# REGIONAL REVIEW FINDING

ARC REVIEW CODE: R708031

**Submitting Local Government:** City of Smyrna  
**Name of Proposal:** Jonquil Village

Preliminary Report:	August 3, 2007	<b>DEVELOPMENT OF REGIONAL IMPACT REVIEW REPORT</b>	Project:	Jonquil Village #1277
Final Report Due:	September 2, 2007		Comments Due By:	August 17, 2007

ARCHITECTURAL SITE PLAN #1  
1" = 50'-0"

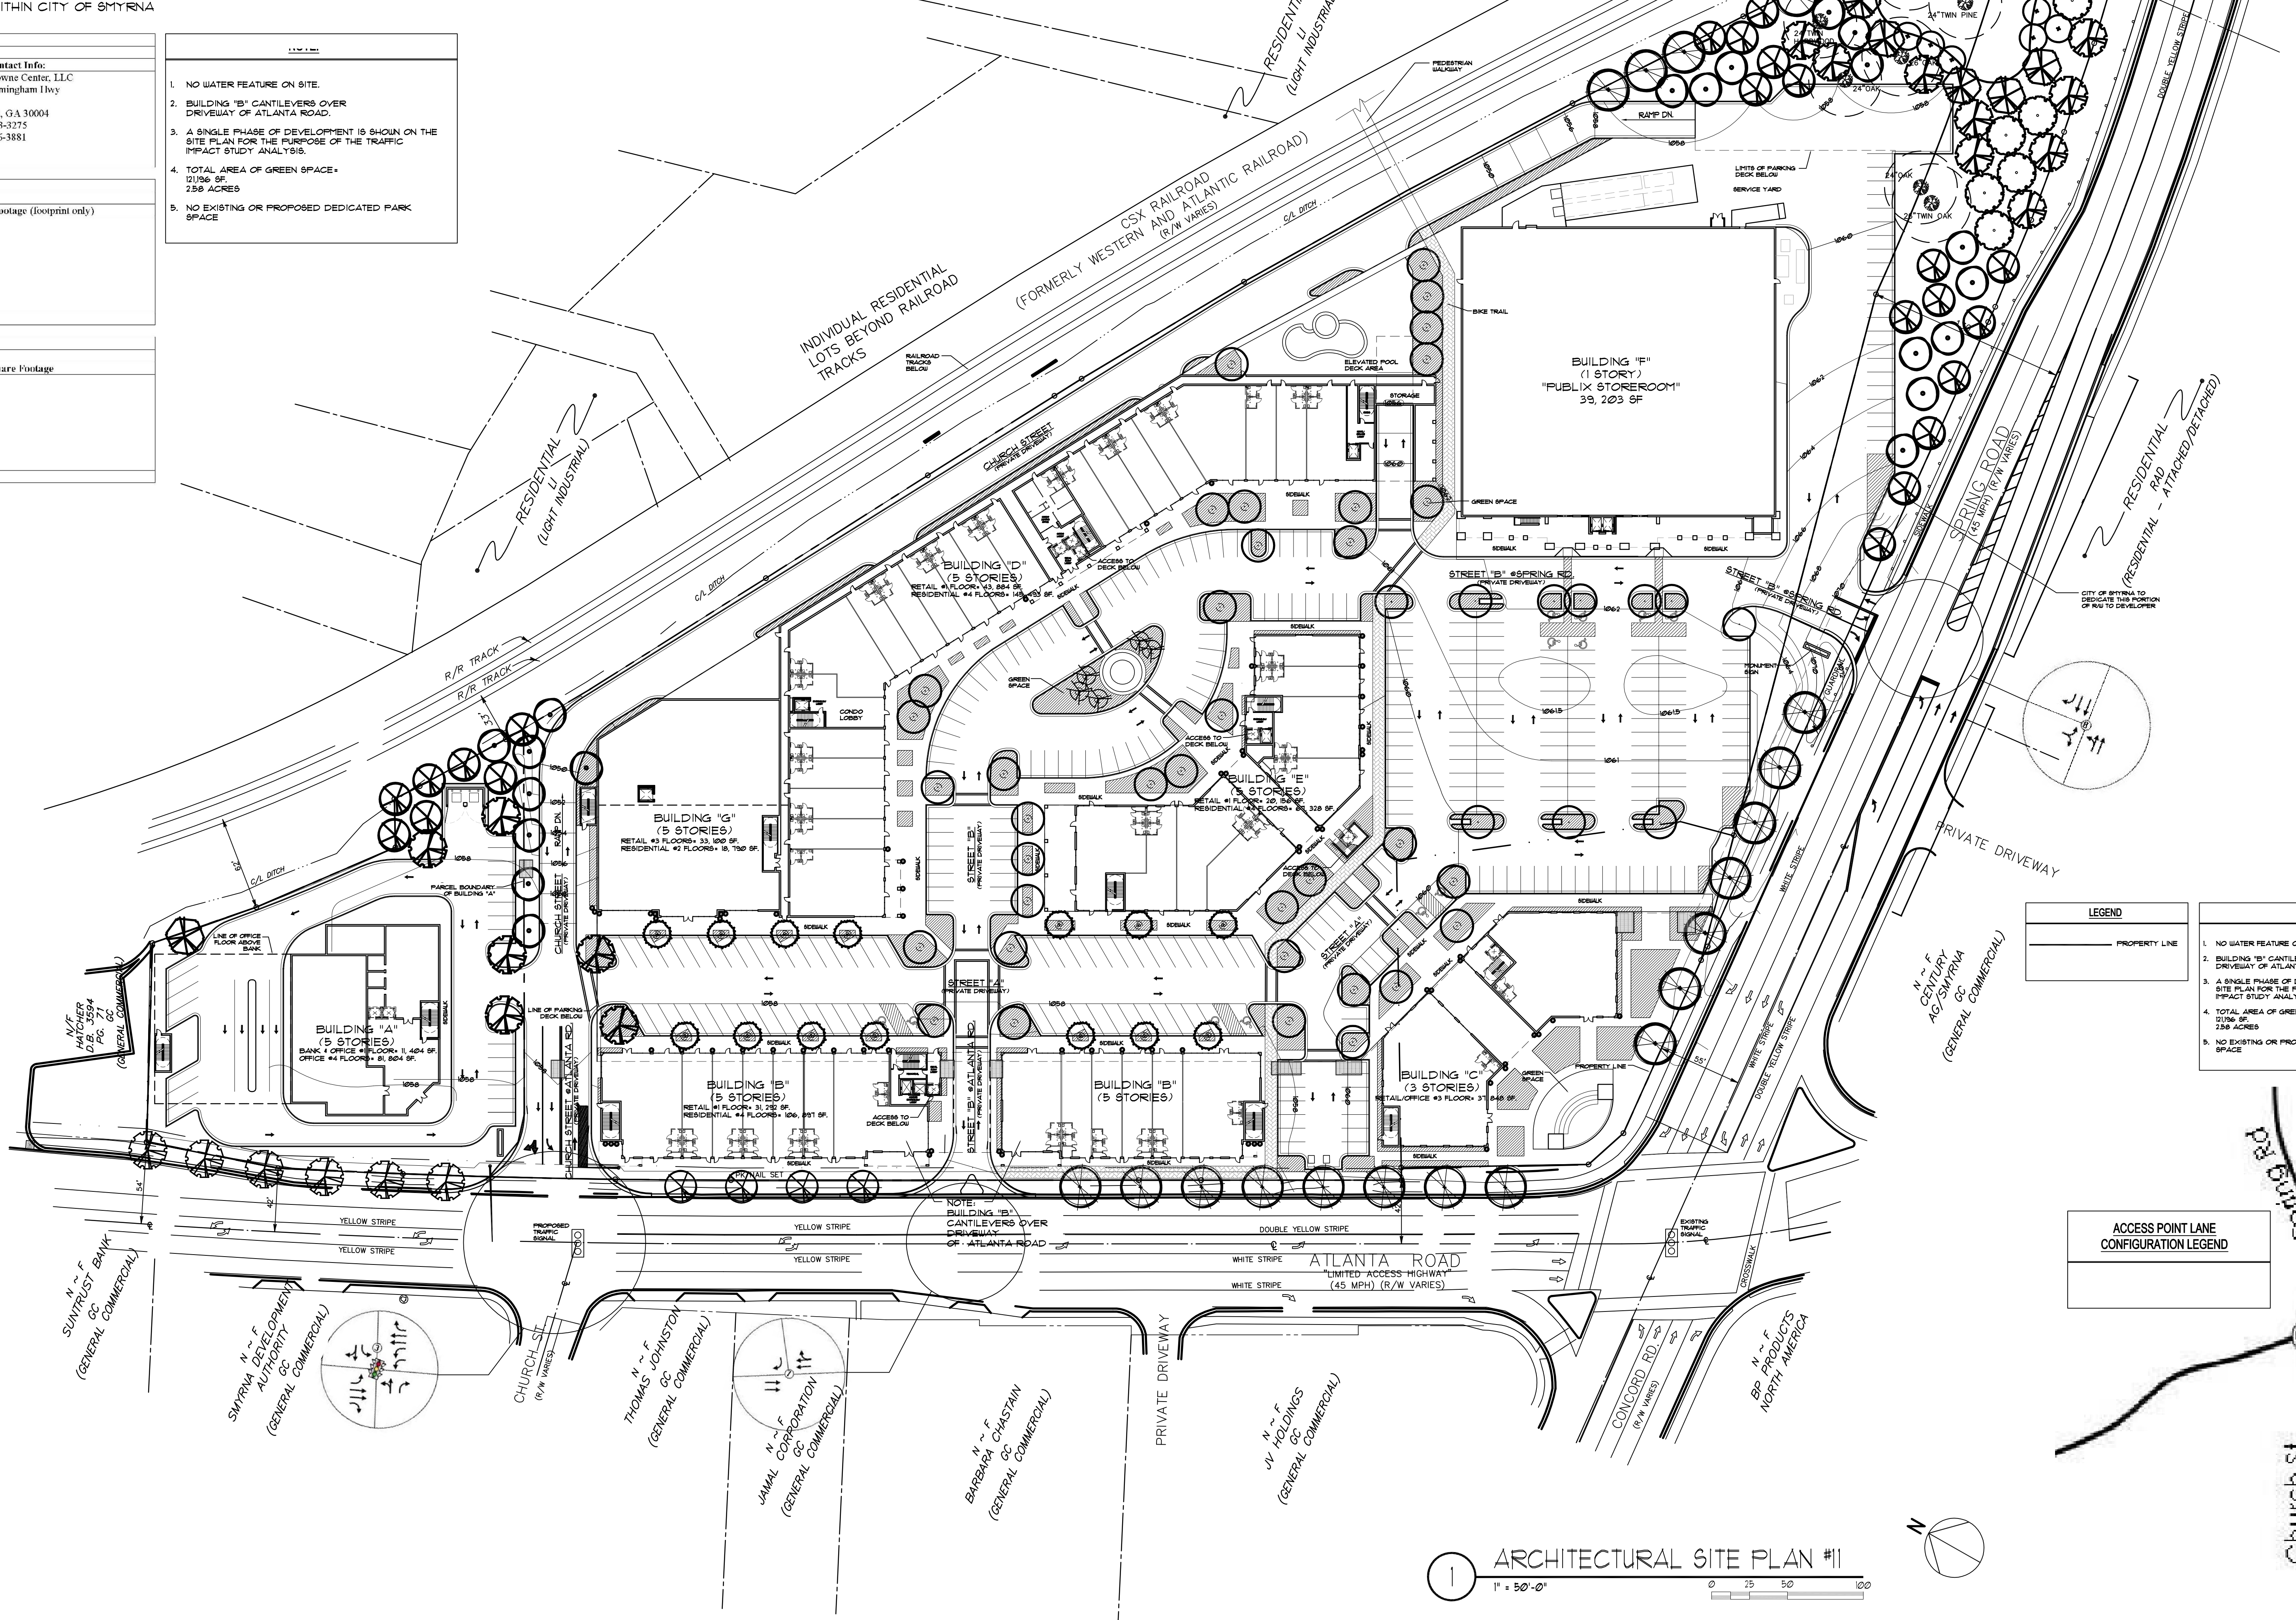
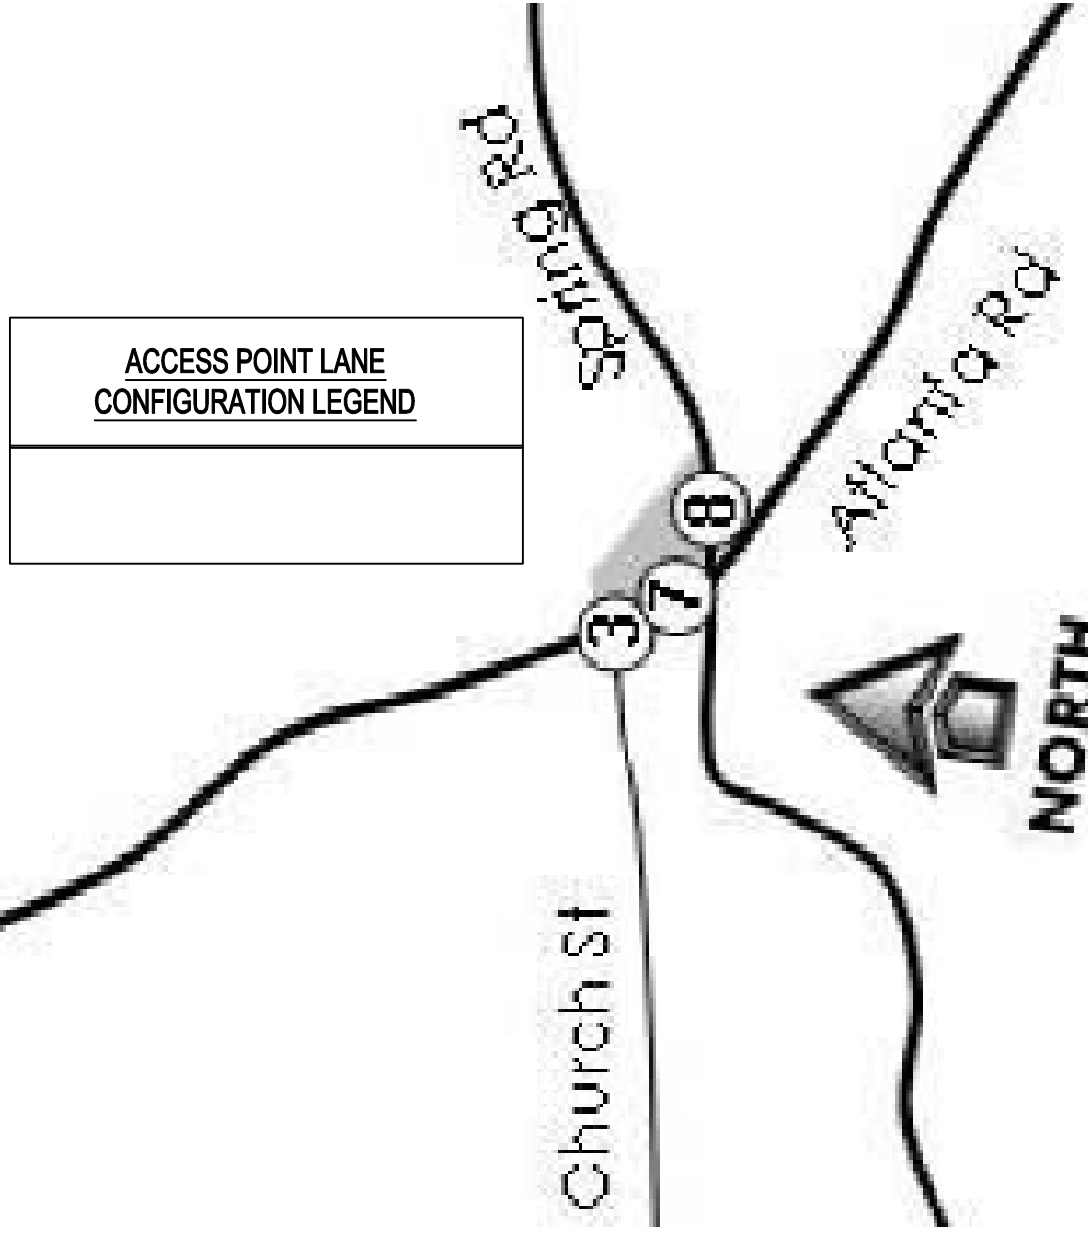
The driveway access to Spring Road should right-right-out unless the applicant can verify that minimum intersection sight distance is available. The minimum requirement is 630'.

Developer to provide 100% funding for an interconnected signal at main driveway if and when warranted.

Recommend applicant verify that minimum intersection sight distance is available and if it is not, implement remedial measures, subject to the Department's approval, to achieve the minimum requirement of 630' along Spring Road.

Recommend developer provide 100% funding for an interconnected signal if and when warranted.
